Subject: [EXT] Tererro Exploration Project - Amended Proposed Drill Pad Locations

Tererro Exploration Project - Table 1 - Amended Proposed Drill Pads

Amended Proposed Drill Pads Tererro Exploration Project

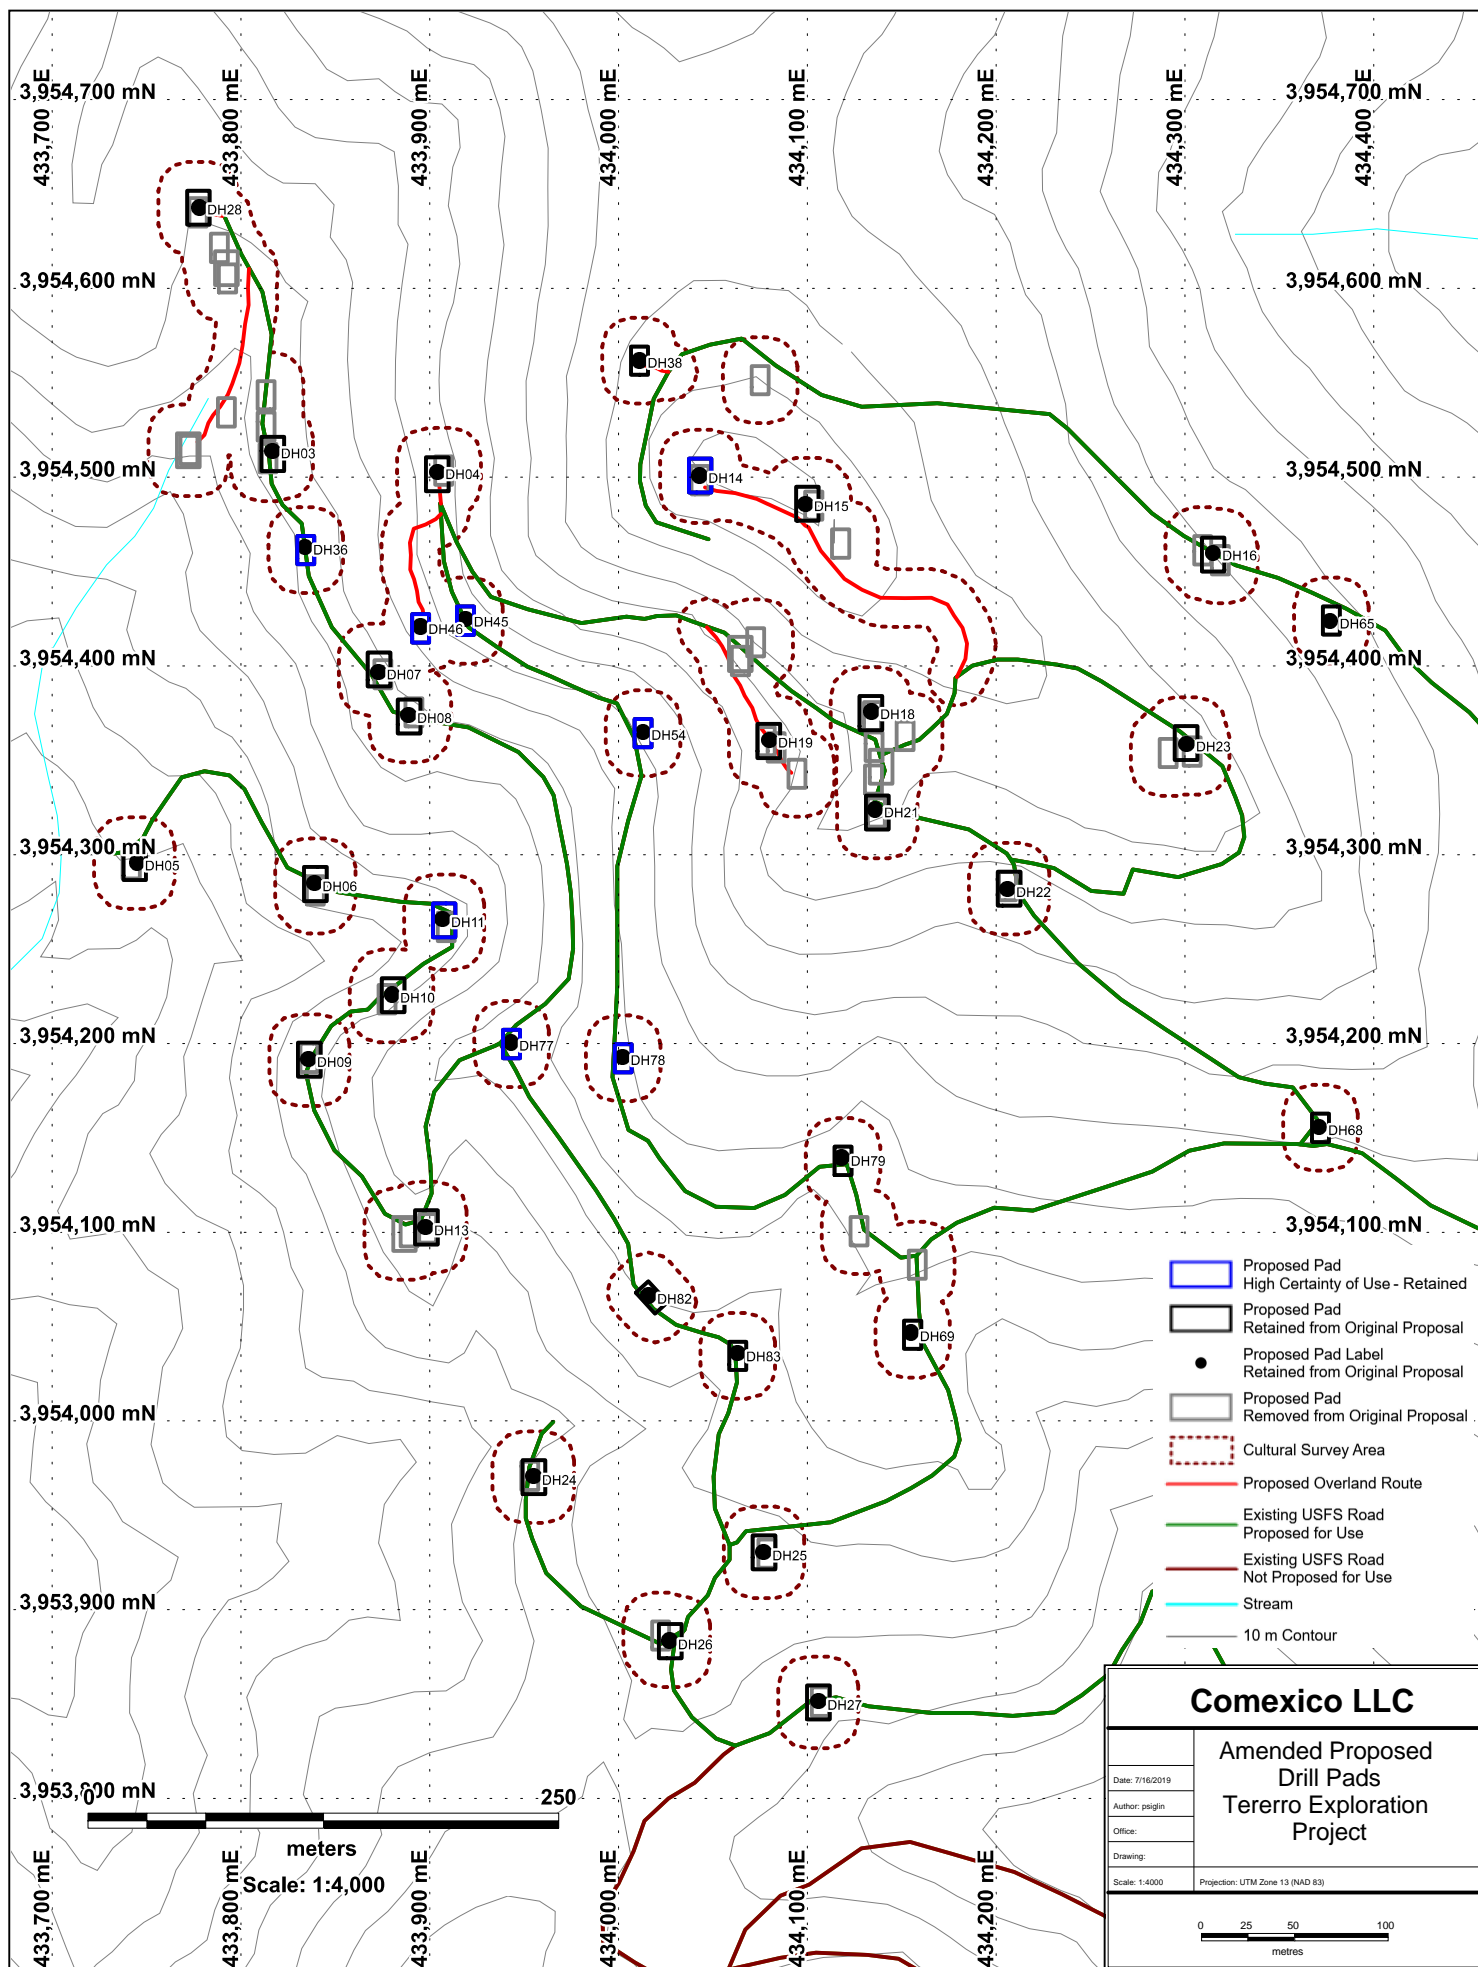
I spent a couple of days at the project area last week and was able to visit the subject proposed drill pad locations and organize an amendment to the originally proposed pads. A large number of the originally proposed 84 pad locations were duplicates at which I had located both the 50 x 30 ft and the 60 x 40 ft pad areas in the same location – these were removed leaving just the 60 x 40 ft pad at the duplicate locations. Another number of near duplicates were then removed; these were those locations which were generally very proximal to another proposed pad location. Then, several locations were removed due to terrain and/or vegetation conditions which would have limited our proposed “minimal impact” pad layout and design. Our final proposed drill pad location count is now a total of up to 36 as compared to the original count of 84.

Please accept this email and the two attachments as an amendment which removes proposed pad locations and highlights those we propose to retain. At the meeting on June 27, Comexico also committed to identifying some of the proposed drill pads that we foresee as having a higher certainty of use based on our current knowledge of the target mineral deposit and thus I have highlighted those pad locations in blue on the attached table and figure – these 8 proposed pads are among the 36 retained locations.

If acceptable, Comexico maintains the original proposal that up to 30 drill holes be approved and that up to 30 drill pads may be drilled from upon.
